Access Compliance Report

Public Rights-of-Way

(Curb Ramps)

Intersection ID: 10570	Main Street: HERRIN_AV	Cross Street: HOLT_ST	Location: SE
ADA ID: D4876ED0CF14	Ramp Type: Perp	Initial Pass/Fail: Fail	Overall Compliance: No
Severity Score: 8.75			
Codes/Mitigation Info/Possible Solution		Field Measurements/Component Compliance

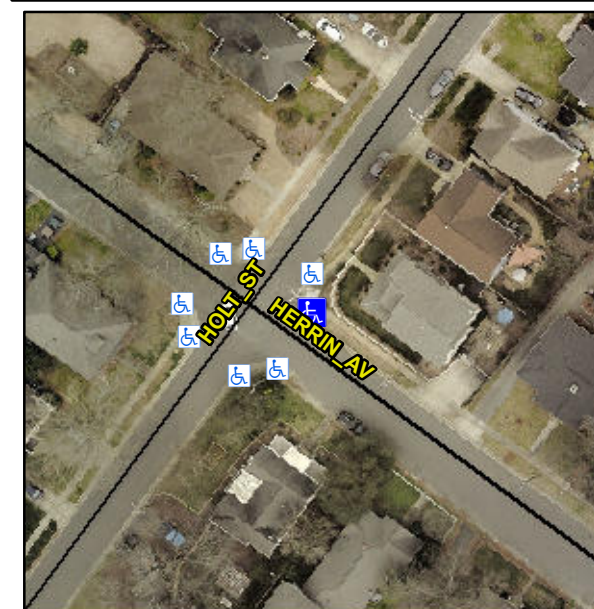
Not Found, R304.5.1

Compliance	Description	Data	Compliance	Description	Data
N/A	Ramp Length (in)	39.5	Yes	Ramp Slope (%)	6.4
No	Ramp Width (in)	47.0	Yes	Ramp XSlope (%)	1.2
N/A	Flare Type LT	N/A	N/A	Flare Type RT	N/A
N/A	Flare Slope LT (%)	N/A	N/A	Flare Slope RT (%)	N/A
N/A	Flare Traversable LT?	N/A	N/A	Flare Traversable RT?	N/A
N/A	Landing Length (in)	N/A	N/A	DWS Provided?	N/A
N/A	Landing Width (in)	N/A	N/A	DWS Contrast?	N/A
N/A	Landing Slope (%)	N/A	N/A	DWS Length (in)	N/A
N/A	Landing X Slope (%)	N/A	N/A	DWS Full Width?	N/A
N/A	Landing Curb? (Y/N)	N/A	N/A	DWS Offset (in)	N/A
N/A	Shared Landing?	N/A			
N/A	Gutter Ponding?	N/A	N/A	Gutter Slope (%)	N/A
N/A	Gutter Lip Ht (in)	N/A	N/A	Gutter X Slope (%)	N/A
N/A	Painted X Walk1?	No	N/A	Painted X Walk2?	N/A
	X Walk 1 Direction	To SW		X Walk 2 Direction	N/A
N/A	X Walk 1 Width (in)	N/A	N/A	X Walk 2 Width (in)	N/A
	X Walk 1 Slope (%)	0.1		X Walk 2 Slope (%)	N/A
	X Walk 1 X Slope (%)	1.9		X Walk 2 X Slope (%)	N/A

Remove & Replace Entire Ramp.
